From Leo Bellantoni

- 1) You have a list of findings from Steve Chappa
- 2) Likewise Karen Kephart
- 3) and from Jim Priest, a single additional finding.

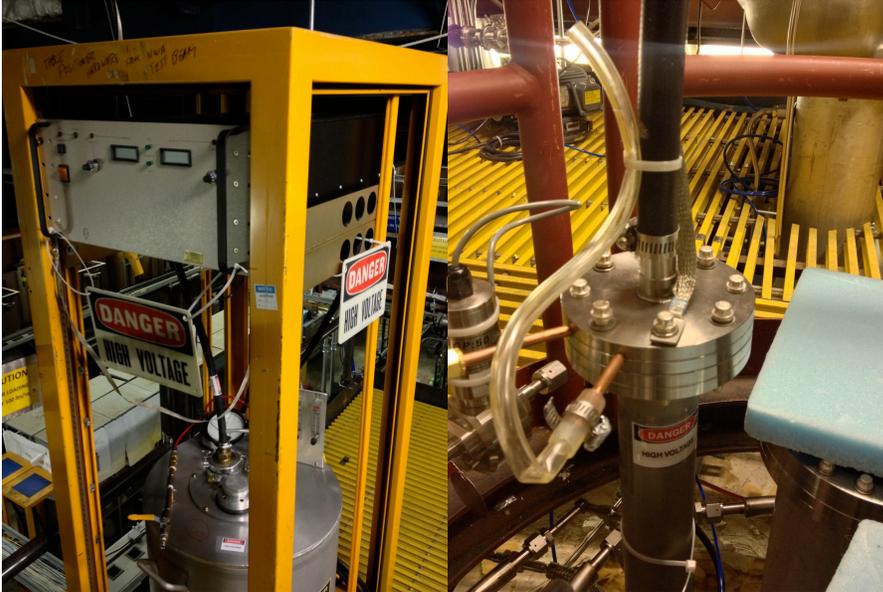
1. The DC and AC power wiring inside of the CCU chassis, which is a custom-built chassis, is not clear from the schematic and description. Therefore, I will need to physically look inside the chassis to examine the safety grounding and power wiring details. Also, the schematic needs to be updated/completed so as to include this information.

One spare CCU chassis is at the Proton Pole Building (PPB) ready for inspection. We also updated the documentation for the CCU chassis:

http://lartpc-docdb.fnal.gov/0008/000860/006/CCU_information_v2.pdf

which provides dialog to accompany CCU schematics:

http://lartpc-docdb.fnal.gov/0008/000860/006/CCU_PAD_schematics_bromberg.pdf

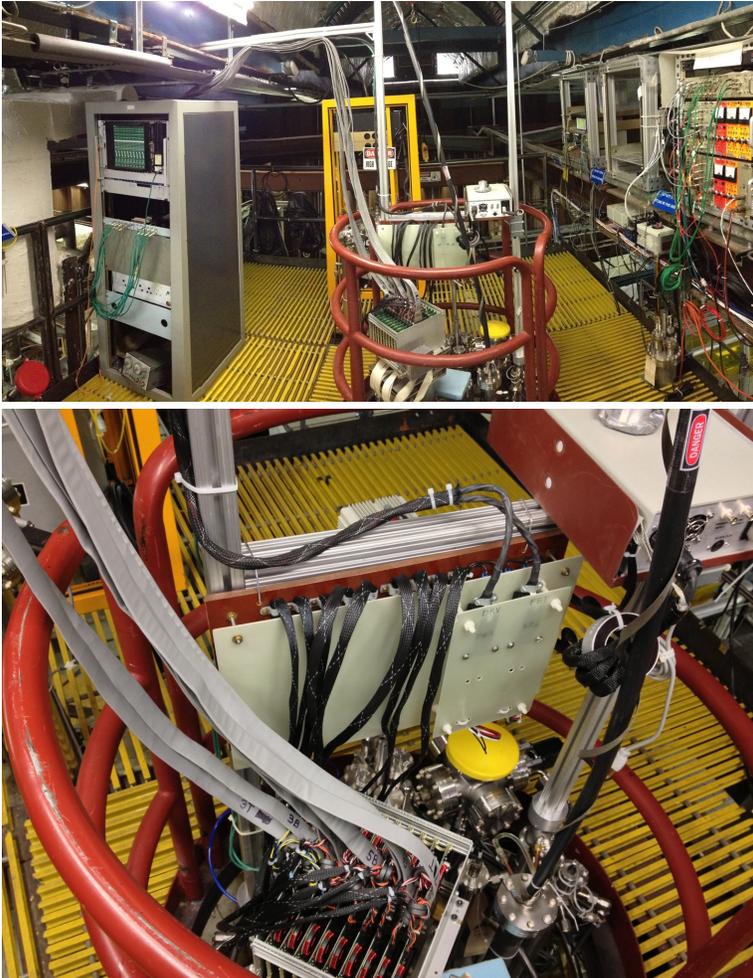
The TPC electronics rack located on the catwalk at the top of the vessel needs to have rack protection provided of the type that includes (at a minimum) a smoke detector wired to turn off power to the rack in case of an alarm.

Rack protection is installed and tested to be functional.

The documentation for the RPS is [http://lartpc-docdb.fnal.gov/0008/000860/006/173865 Test Stand Rack Protection System.pdf](http://lartpc-docdb.fnal.gov/0008/000860/006/173865_Test_Stand_Rack_Protection_System.pdf)
